Irregular Pre- Threshold

Issue identified NPA 2018-06 (B-C-D)

Thierry Bourret
15th October 2018

AIRBUS

Figure 1 : Upper and lower limit of irregular pre-threshold terrain

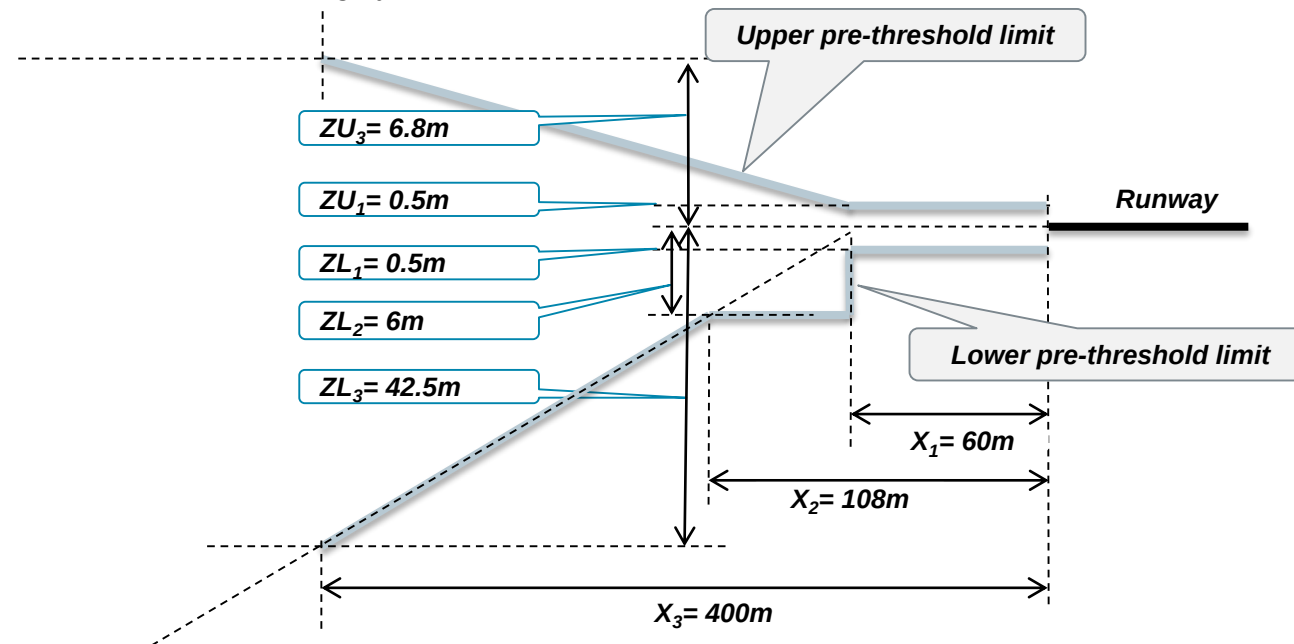
If pre-threshold terrain presents significant variation, compatibility should be checked against limits used to certify aircraft systems providing flare guidance. If pre-threshold terrain is below or above the lower and upper limit defined in Figure 1 within the 400m prior the runway threshold, then the terrain should be classified as “irregular” as it may not be suitable with aircraft landing systems.

ZU_3 derived from 2% slope as per GM1 ADR-DSN.B.205 Radio altimeter operating area

ZU_1 ZL_1 derived from standard Radio altimeter precision (+/- 3ft)

ZL_2 derived from 6m see wall as per AMC AWO.A.ALS.107 §5.2.2.c

ZL_3 derived from -12.5% slope starting at 60m as per AMC AWO.A.ALS.107 §5.2.2.b

X_3 derived from conservative hypothesis on AIRBUS family highest flare height (70ft)

For runways intended to be used for low visibility operation, pre-threshold terrain chart should be published as per ICAO Doc 9365 Manual of All-Weather Operations

Example “regular” and “irregular” pre-threshold as per new definition

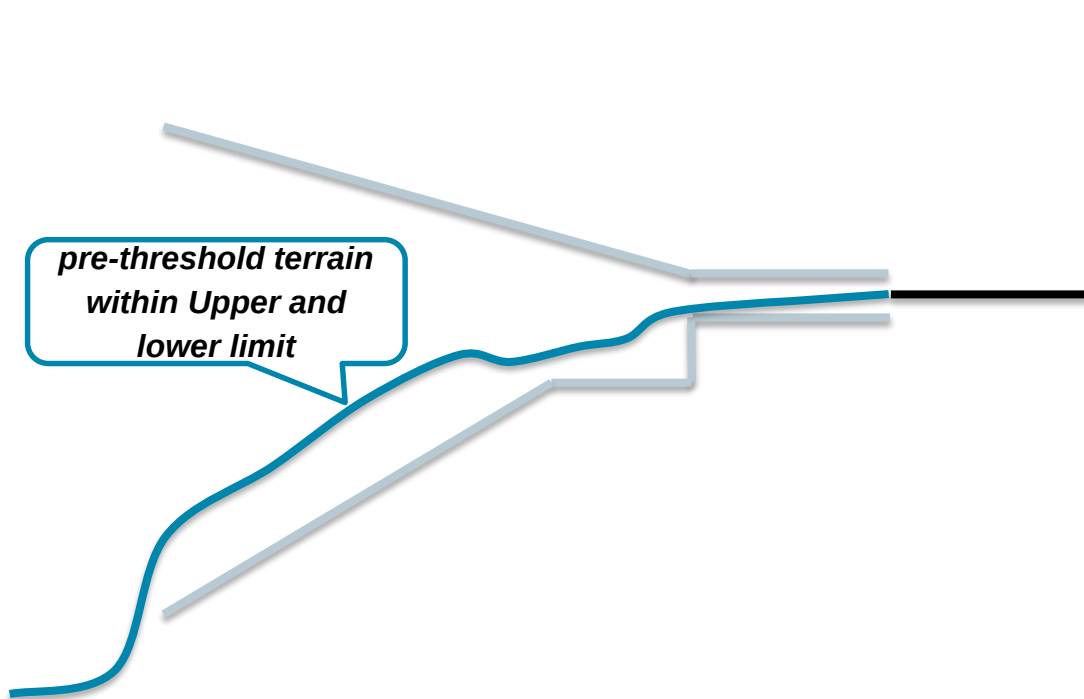
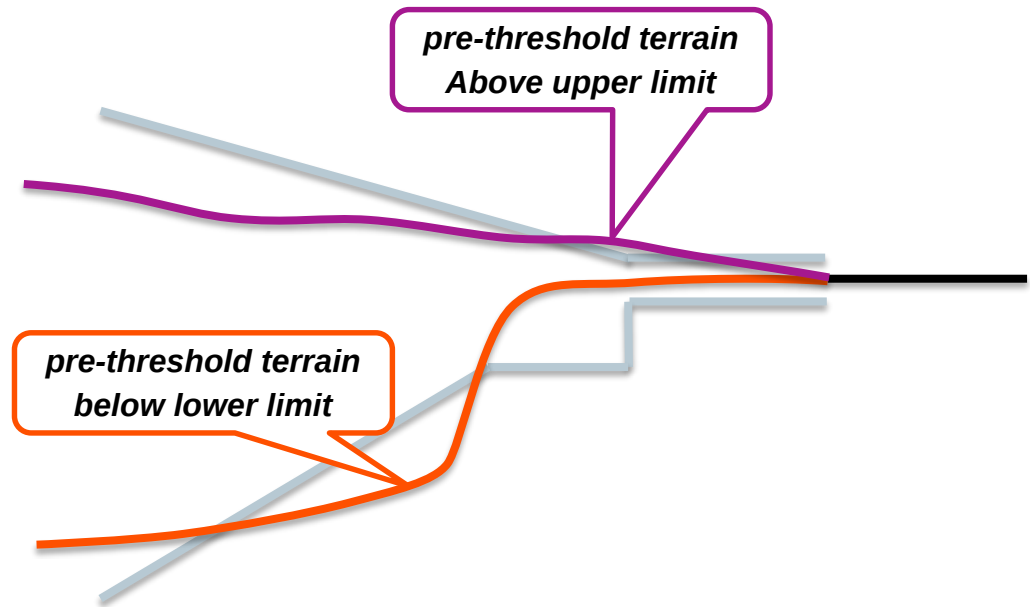
Example of pre-threshold terrain within Upper and lower limits

Example of pre-threshold terrain above upper limits or below lower limit
